# HISTORIC AND DESIGN REVIEW COMMISSION

**HDRC CASE NO:** 2020-448  
**ADDRESS:** 415 HAYS ST  
**LEGAL DESCRIPTION:** NCB 528 BLK 1 LOT 12  
**ZONING:** IDZ-1, H  
**CITY COUNCIL DIST.:** 2  
**DISTRICT:** Dignowity Hill Historic District  
**APPLICANT:** Juan Fernandez/CVF LLC  
**OWNER:** CVF LLC  
**TYPE OF WORK:** Construction of three, 2-story residential structures  
**APPLICATION RECEIVED:** December 18, 2020  
**60-DAY REVIEW:** Not applicable due to City Council Emergency Orders  
**CASE MANAGER:** Edward Hall

The applicant is requesting a Certificate of Appropriateness for approval to construct three, 2-story, single-family residential structures on the vacant lot at 415 Hays, located within the Dignowity Hill Historic District.

1 EAST ELEVATION  
1/4 SCALE

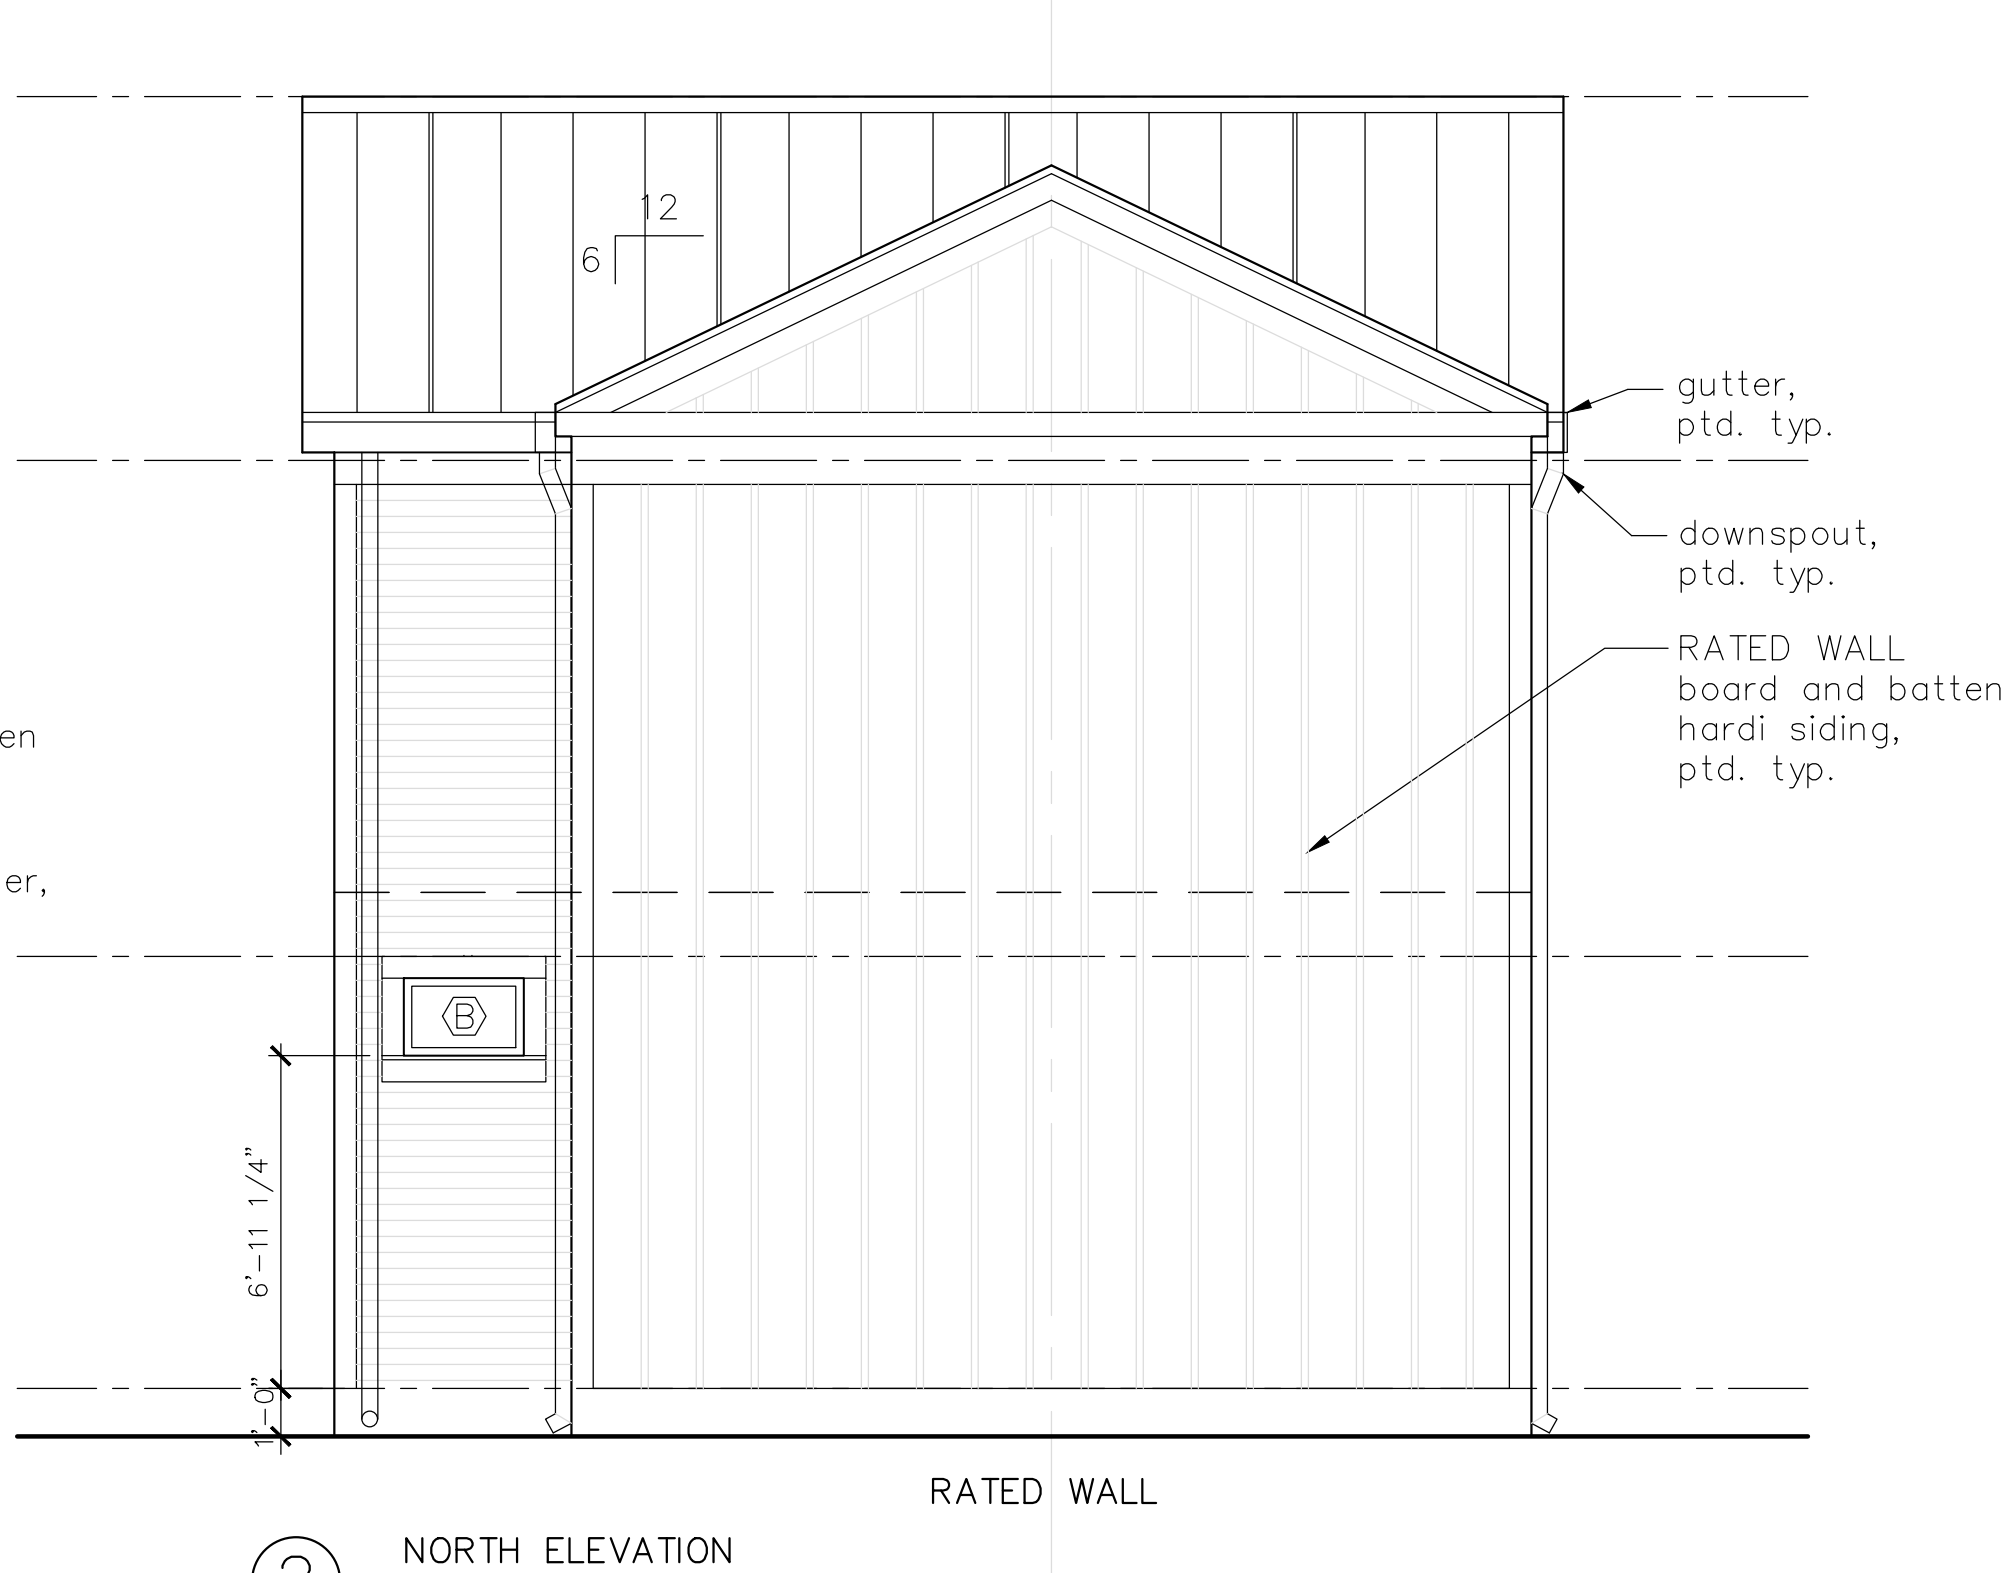
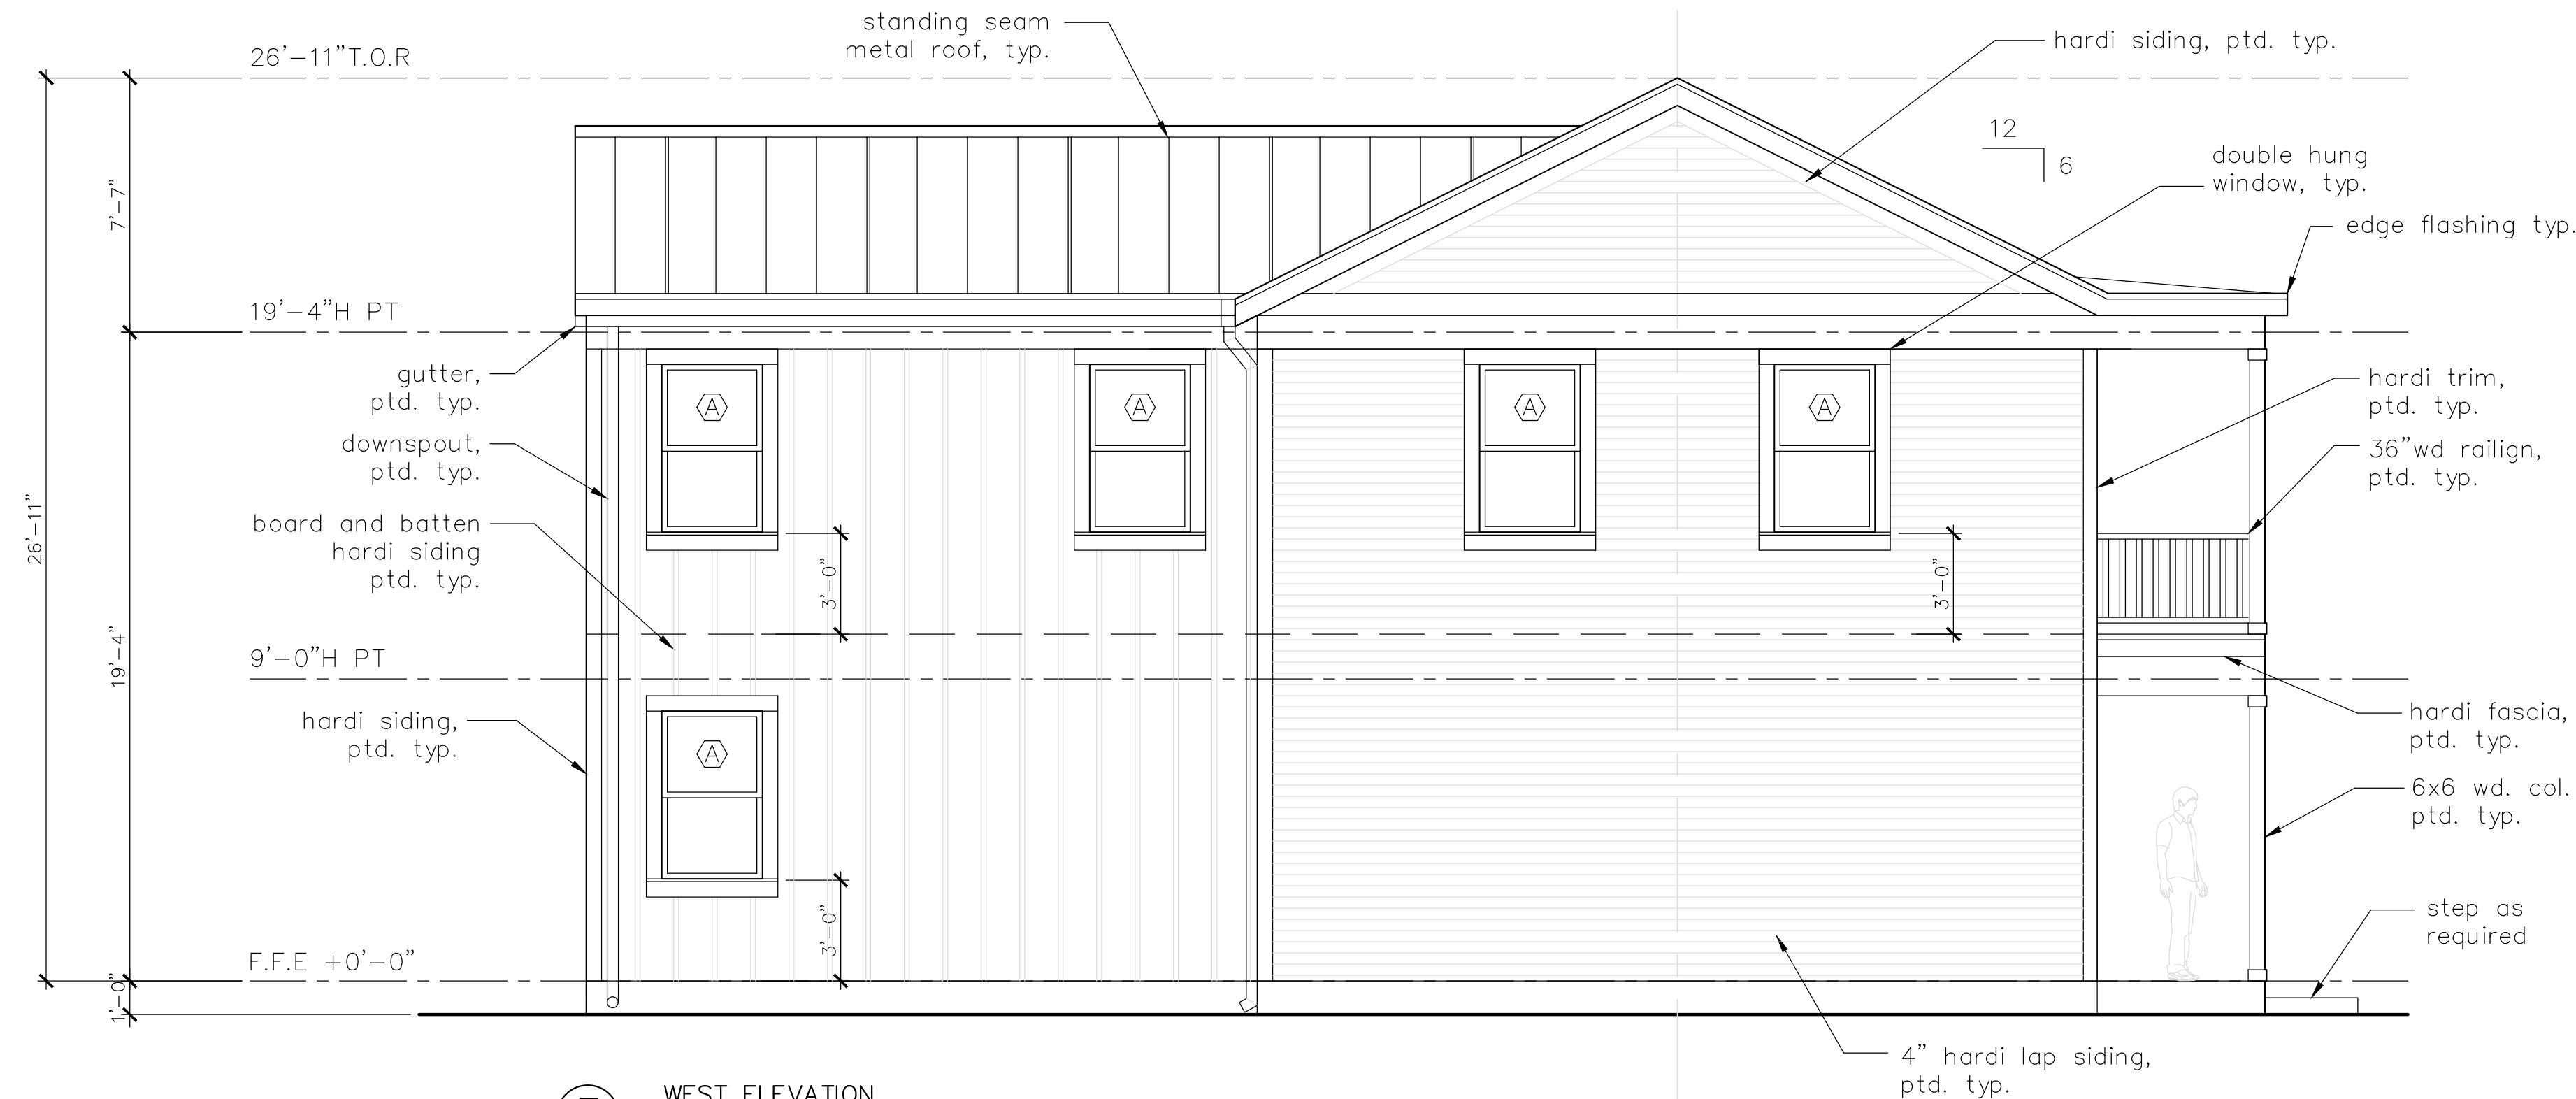
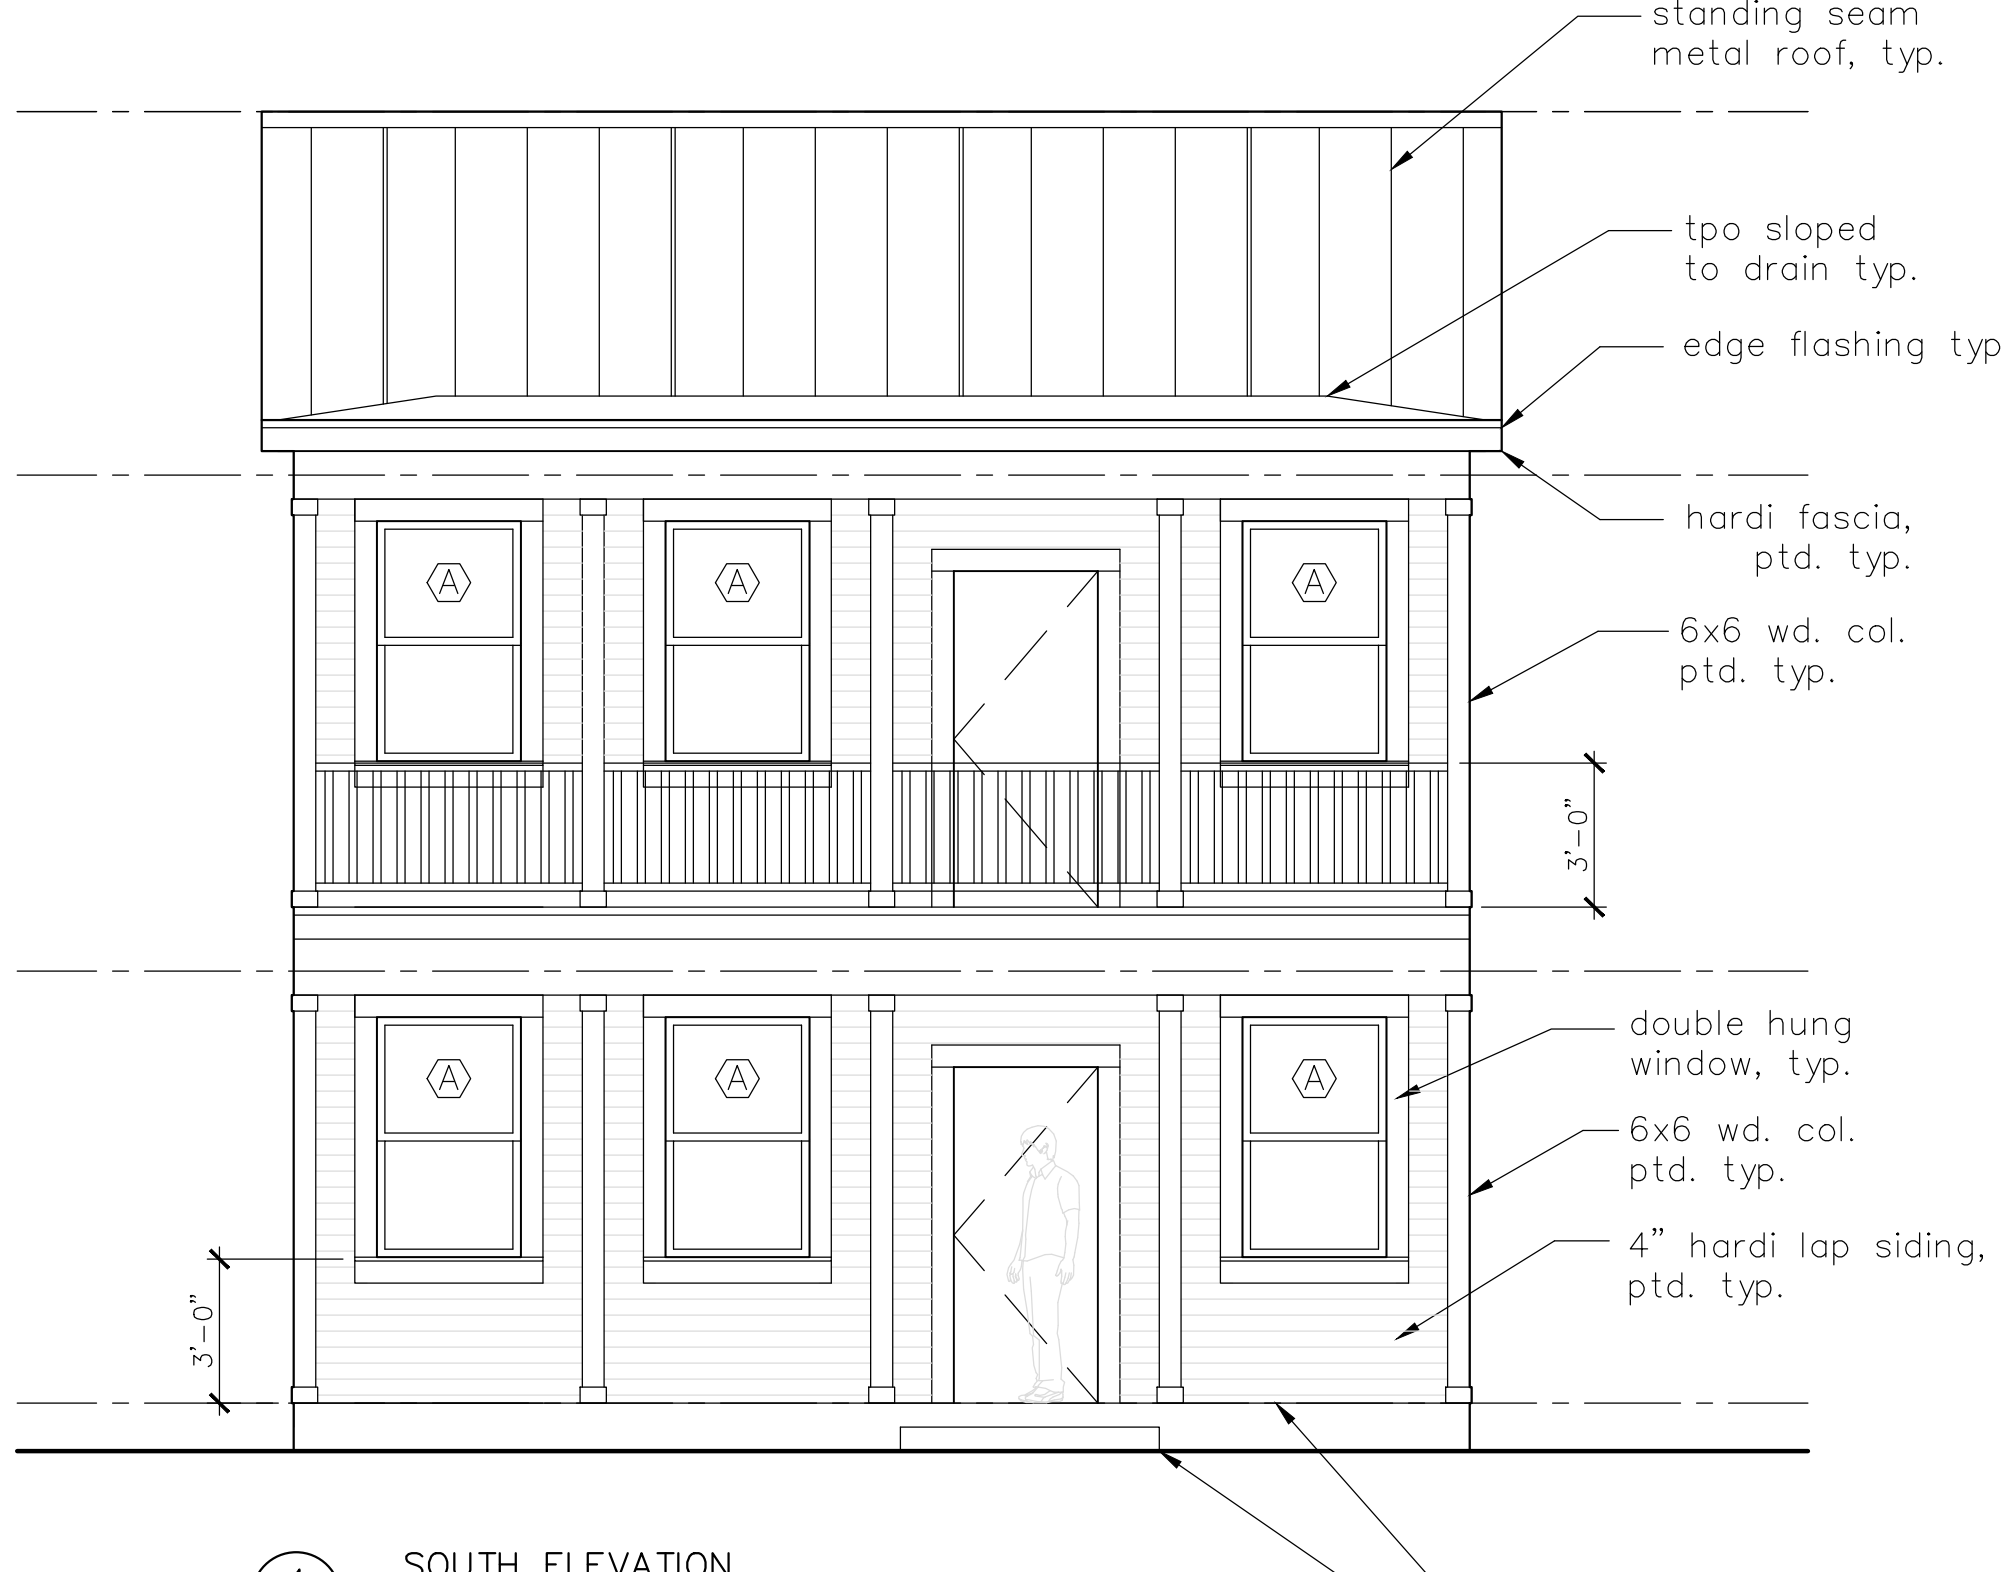
- h. SCALE & MASS – Per the Guidelines for New Construction 2.A.i., a height and massing similar to historic structures in the vicinity of the proposed new construction should be used. In residential districts, the height and scale of new construction should not exceed that of the majority of historic buildings by more than one-story. Per the submitted massing models, the applicant has proposed an overall height of two (2) stories. As noted in finding d, there are two story historic structure in the immediate vicinity. Generally, staff finds the proposed height to be appropriate for the front structure addressing Hays. At the time of conceptual approval, staff recommended that the applicant decrease the massing of the middle and rear structures. The applicant has provided a site elevation showing a change in grade that results in the appearance of the middle and rear structures featuring a reduced massing. Staff finds that the massing of portions of the structures should be reduced to alleviate the visual impacts of multiple, two-story structures. In particular, the ridge height and roof forms of the portions over proposed garages should be reduced in order to improve the perceived open space between the structures to be consistent with the historic development pattern.

- j. ROOF FORMS – The applicant has proposed roof forms that include side facing gabled roofs and rear facing gabled roofs. Staff finds the proposed roof forms and their profiles to be appropriate and consistent with the Guidelines.

- l. MATERIALS – The applicant has proposed materials that include standing seam metal roofs, smooth composite siding in both a lap and board and batten profile, and fiberglass windows. Staff find that the proposed standing seam metal roof should feature smooth panels that are 18 to 21 inches wide, seams that are 1 to 2 inches in height, a crimped ridge seam or low profile ridge cap and a standard galvalume finish. If a low profile ridge cap is used, it must be approved. Regarding siding, staff finds the use of smooth faced composite siding to be appropriate; however, lap siding should feature a found (4) inch exposure, a thickness of  $\frac{3}{4}$  of an inch and mitered corners and that board and batten siding should feature boards that are approximately 12 inches wide

- p. PARKING – The applicant has proposed for each structure to feature attached garages. At the time of conceptual approval, the design featured open air parking, but with similar locations. Parking within the footprint of the primary structure is not found historically within the district; however, staff generally finds the proposed parking solution to be appropriate. Due to the new inclusion of garage doors, staff finds that each garage should feature two separate garage doors that feature windows.

- ii. That the proposed standing seam metal roof feature smooth panels that are 18 to 21 inches wide, seams that are 1 to 2 inches in height, a crimped ridge seam or low profile ridge cap and a standard galvalume finish. If a low profile ridge cap is used, it must be approved. Regarding siding, staff recommends the use of smooth faced composite siding to be appropriate; however, lap siding should feature a four (4) inch exposure, a thickness of ¾ of an inch and mitered corners and that board and batten siding should feature boards that are approximately 12 inches wide with battens that are approximately 1 – ½ inch in width. Columns are to feature six inches square with capital and base trim.

- iv. That the proposed garage doors be separated to feature two doors at each garage and that each garage door feature windows.
- v. That the applicant produce massing for the middle and rear structures that appears to be subordinate to the primary structure on Hays, such as reduced ridge heights or one story massing at each garage.
